CALIFORNIA COASTAL COMMISSION

COASTAL DEVELOPMENT PERMIT APPLICATION

- Application number**3-06-033, Pebble Beach Golf Links, 5th Green Seawall
- Applicant**.....Pebble Beach Company (Cheryl Burrell)
- Project location**Pebble Beach Golf Links 5th Hole (APN 008-403-003), Pebble Beach (Monterey County).

Exhibit G – page 1 of 2
Proposed Site Plans and Elevations

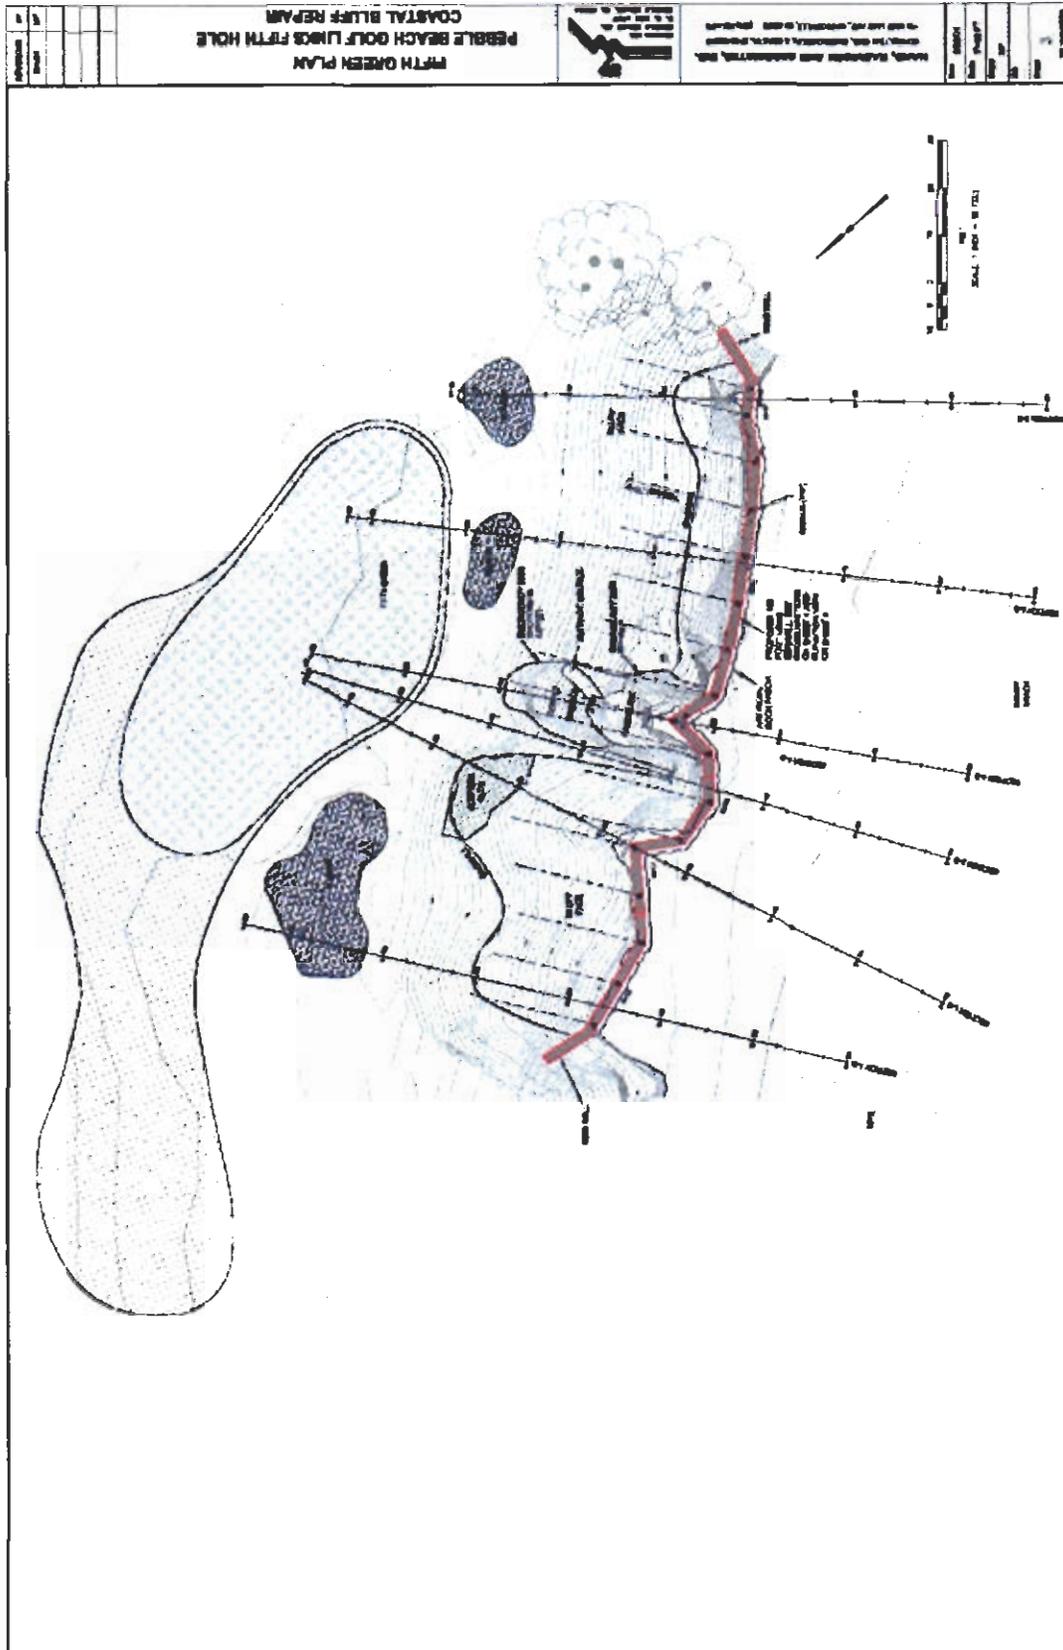
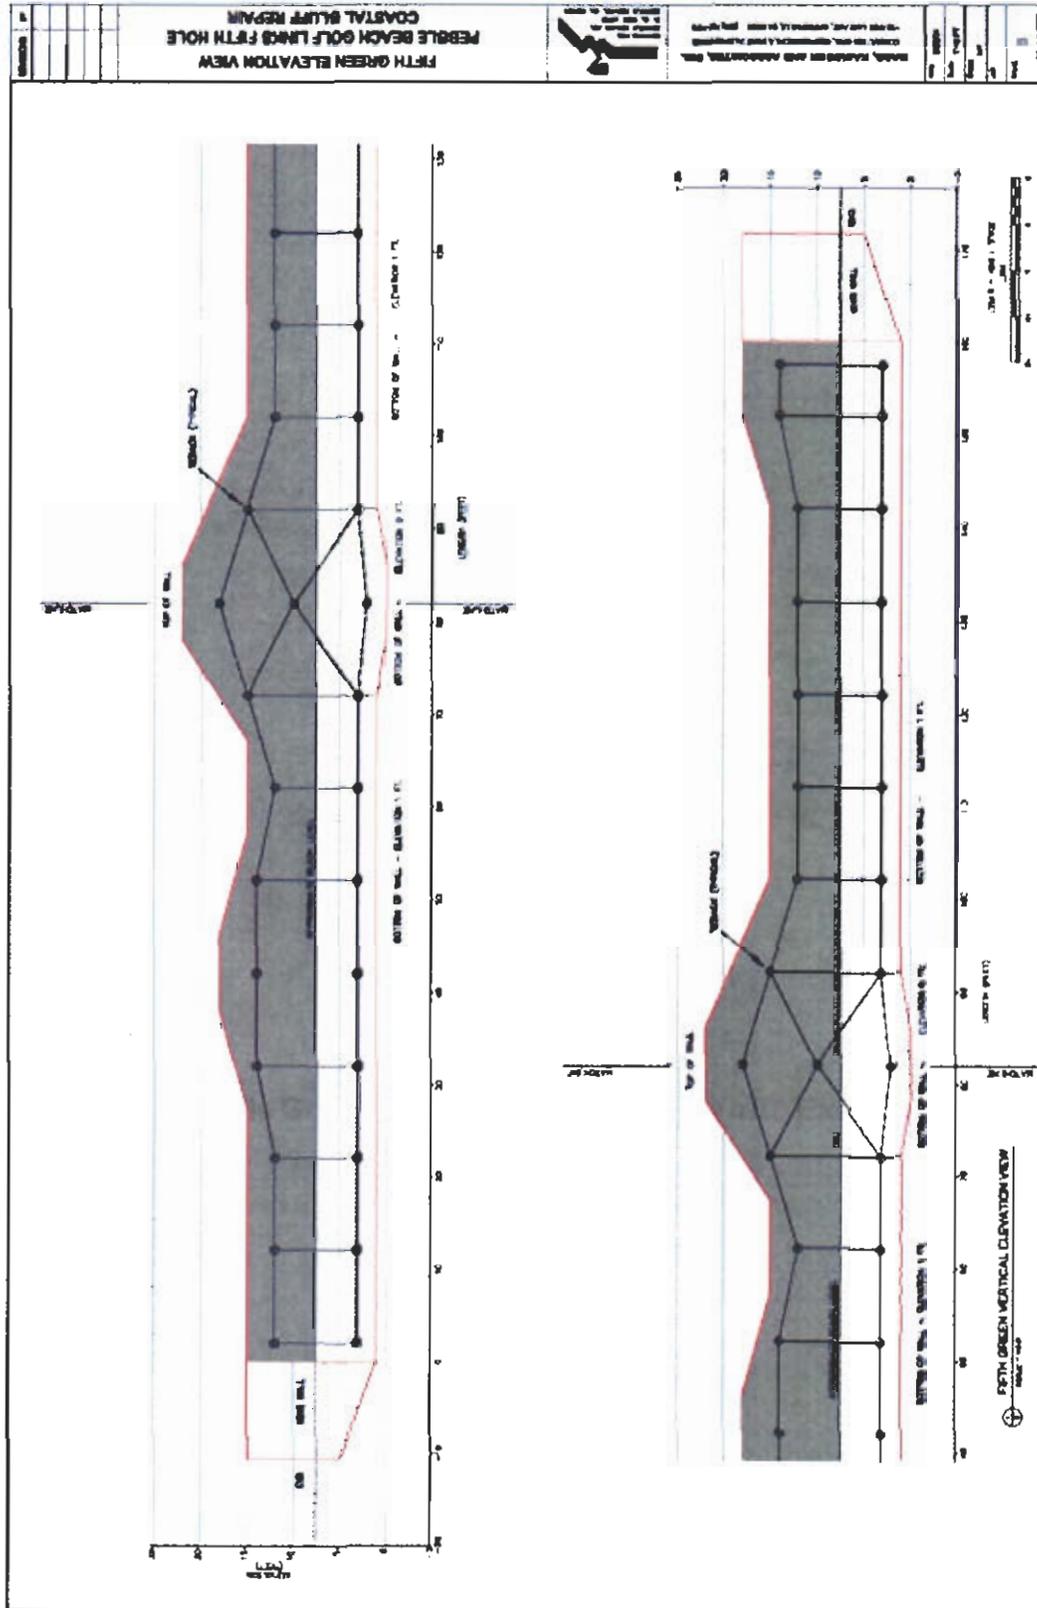
The portion of either seawall that is keyed into the bedrock below the toe of the bluff will cover approximately 320 square feet of beach. Project plans dated 5/04 show that the seawall would be keyed in to bedrock to a bottom elevation of 1 foot MSL (mean high tide is at 1.6 feet MSL). Wing walls will

extend 11 feet on either side of the 5th green seawall to further key the walls into the existing bluff. The Coastal Commission staff coastal engineer, Lesley Ewing, reviewed the project plans, and noted that while the wing walls do extend somewhat beyond the immediate area at risk, they are not excessive, and do not require modification. She also concurred with the HKA assessment that the position of the end of the wing walls are located in the best locations to tie into the natural bluff face, and should minimize future required maintenance on the seawall and minimize the need to expand the seawall in the future.

- A. **Final Engineered Project Plans.** Final plans shall show all components of project in plan view, elevation, and cross section and incorporate all geotechnical recommendations made in the geotechnical reports conducted for the project by Haro Kasunich and Associates (HKA 5/04, HKA 6/04, HKA 8/04, HKA 5/06a and 5/06b, and HKA 7/06). Evidence of the Geotechnical Engineer's review and approval of the plans shall accompany final plan submittal. At least once a week, the geotechnical engineer shall conduct an inspection during construction to ensure effective implementation of geotechnical recommendations.
